**FINDINGS AND RECOMMENDATION
OFFICE OF PLANNING AND ZONING
ANNE ARUNDEL COUNTY, MARYLAND**

CASE NUMBER: 2025-0003-V

The applicants are requesting a variance to allow an accessory structure (garage) with less setbacks than required and with greater height than the principal structure on property located at 1086 Walnut Avenue in North Beach.

ADMINISTRATIVE
SITE PLAN

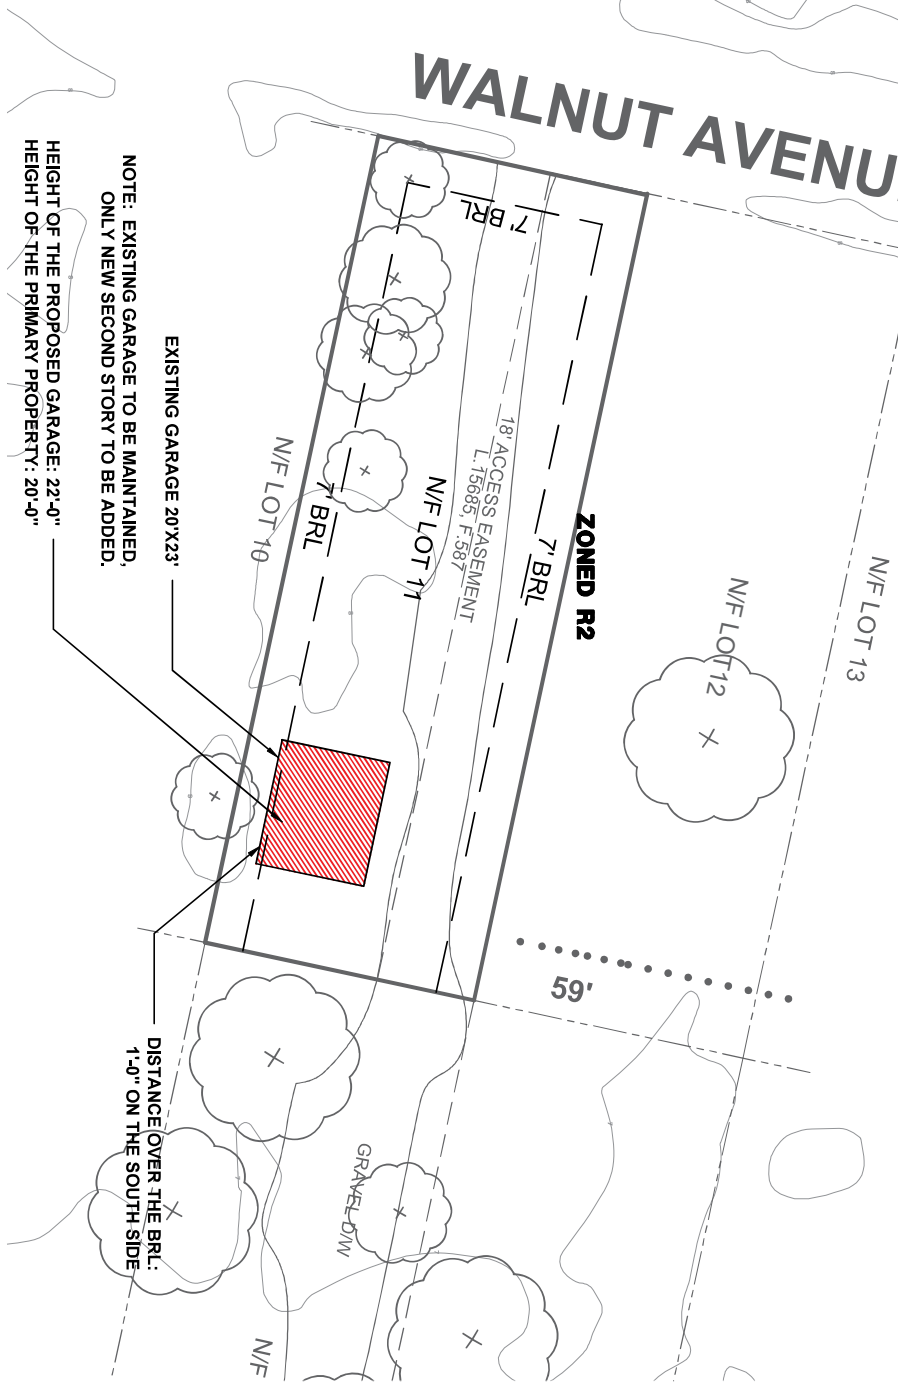
§ 18-4-701 of the Anne Arundel County Zoning Ordinance provides that an accessory structure eight feet in height or greater in an R5 District shall be set back a minimum of seven feet from each side lot line. The proposed garage addition would be located six feet from the south side lot line, necessitating a variance of one foot.

§ 18-4-701 also limits the height of an accessory structure in an R5 District to 25 feet or the height of the principal structure, whichever is less. The existing dwelling is 20' high; the proposed garage would measure 22' high, necessitating a variance of two feet to the maximum accessory structure height allowed.

Given the long-standing location of the existing garage that can be seen clearly on aerials as far back as 1995, if not earlier, the request for a south side setback variance to construct a second story addition for storage over the first floor garage is justified. However, without any specific justification for the need for a variance to exceed the height of the principal structure, the height variance cannot be supported.

Based upon the standards set forth in § 18-16-305 of the Code under which a variance may be granted, this Office recommends ***approval*** of the requested zoning variance to § 18-4-701 to allow a second story storage addition over the existing garage six feet from the south side lot line. However, this Office recommends ***denial*** of the requested variance to allow an accessory structure higher than the principal structure.
